PLATFORM B

PLATFORM A

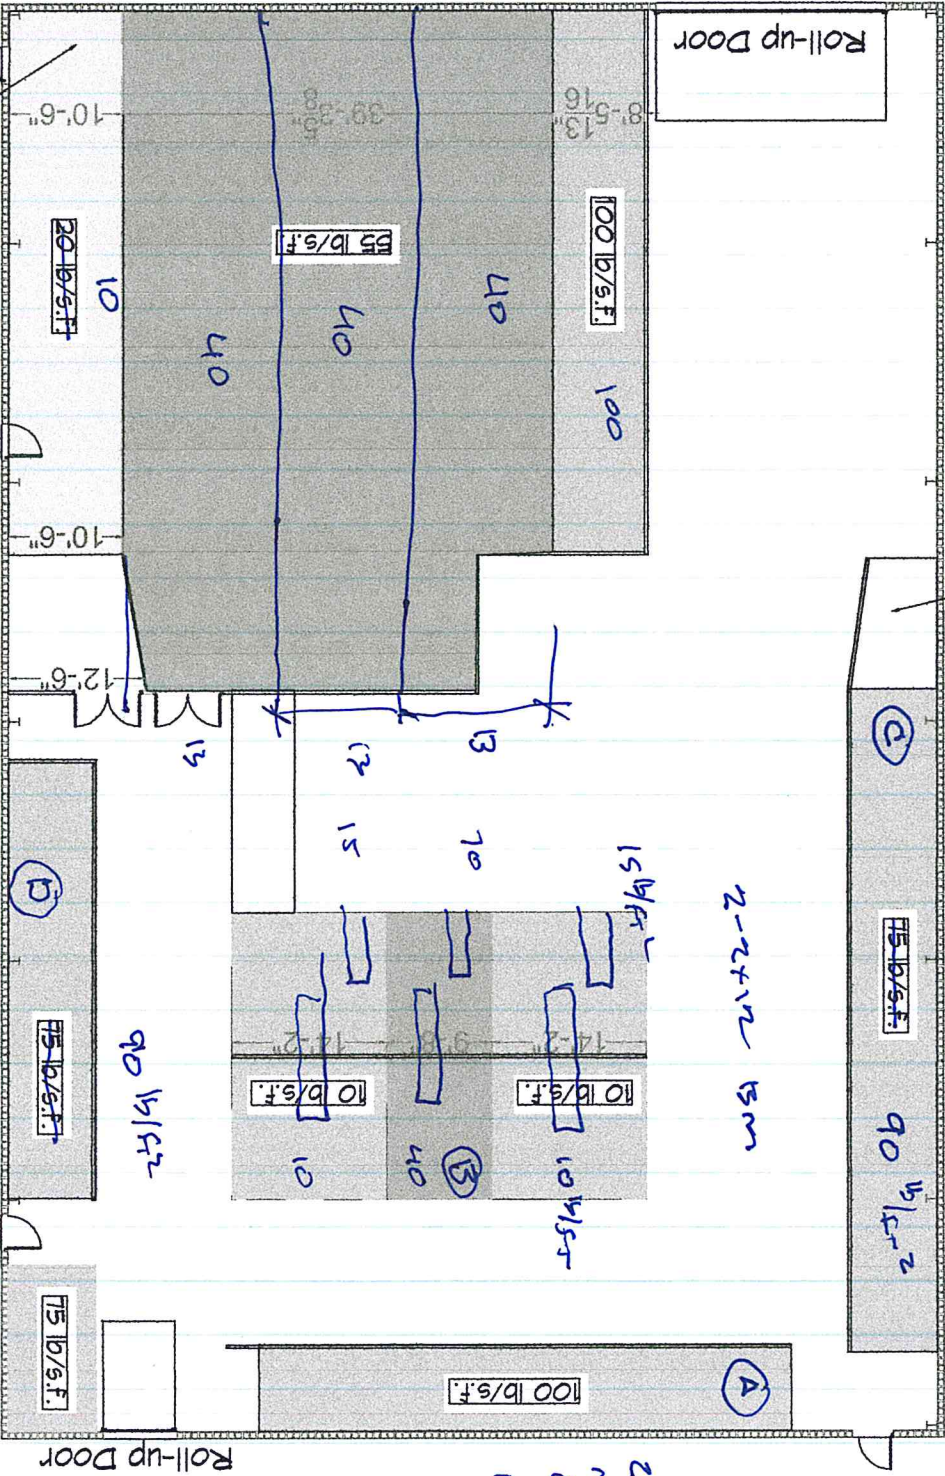
It is not recommended to store anything above this area. Installing a column in the middle of the outside beam will fix this issue. Once corrected it will allow 90 lb/s.f.

This area is limited because of the connection to the CMU wall. If fixed the allowable weight will increase to 90 lb/s.f.
